**ADDISON AIRPORT
BUILDING REPORT**

Facility Information: **Facility Name:** Cavanaugh Flight Museum - Hangar 4
Facility Contact: Lisa Pyles **Contact Phone:** 972-450-2878

Summary Sheet for Cavanaugh Flight Museum - Hangar 4

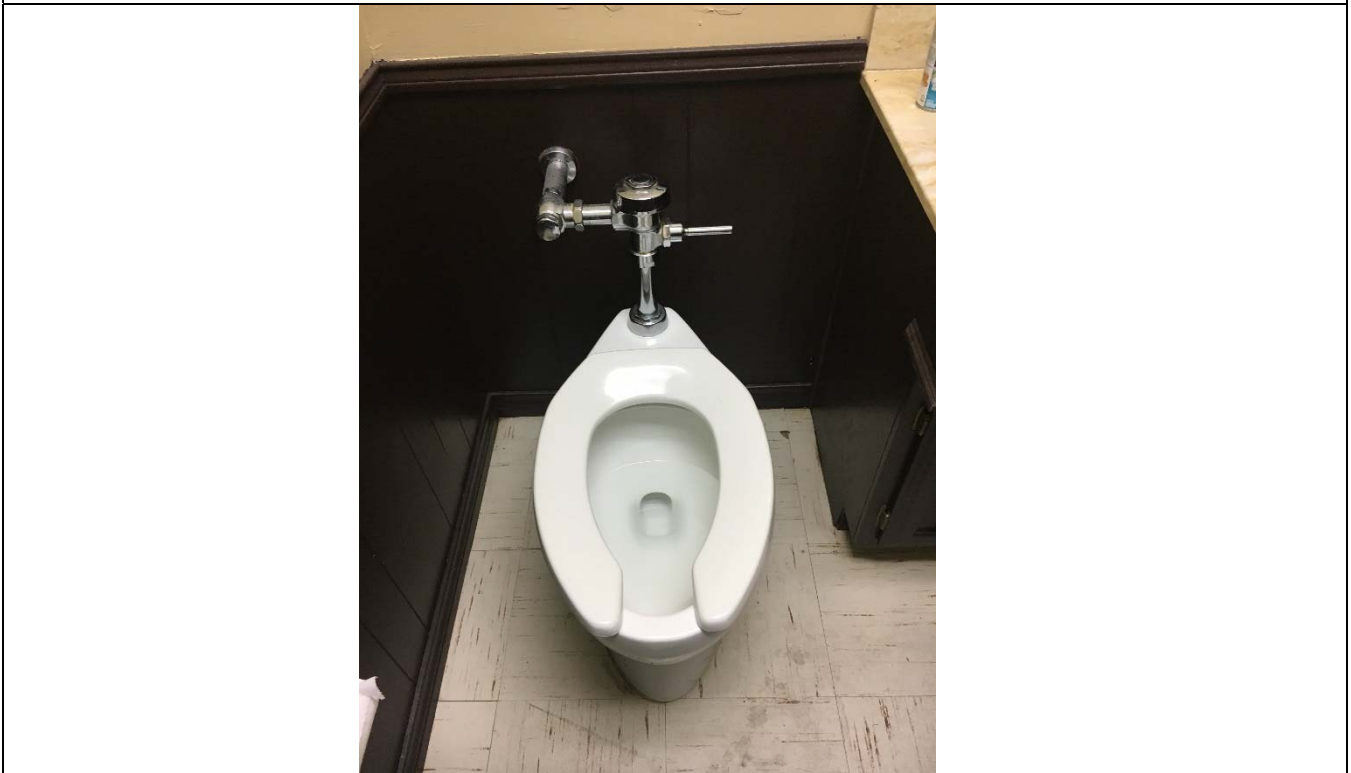
Violation 4 - There are 6 doors in the building with knob style door hardware requiring grasping and twisting to operate.

Replace with lever hardware.

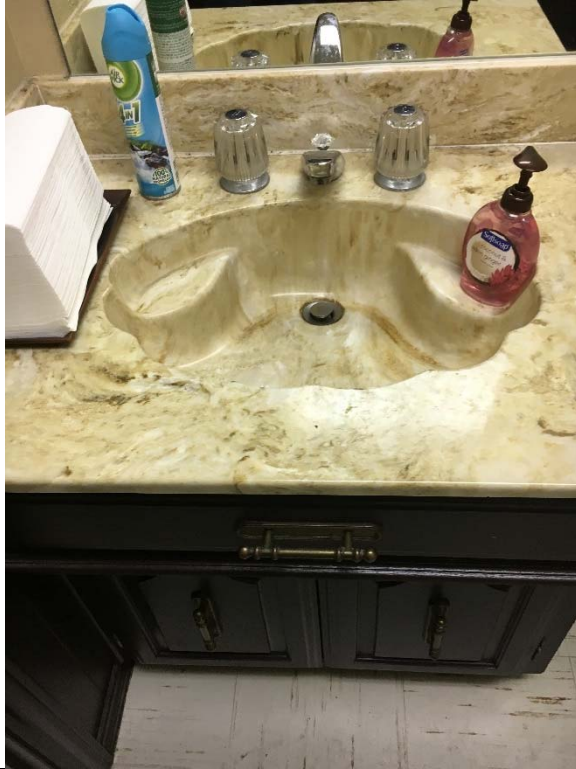
Violation 7 - Office area Women's Room: No rear grab bar is provided and the side grab bar is only 24" long.

Install compliant grab bars.
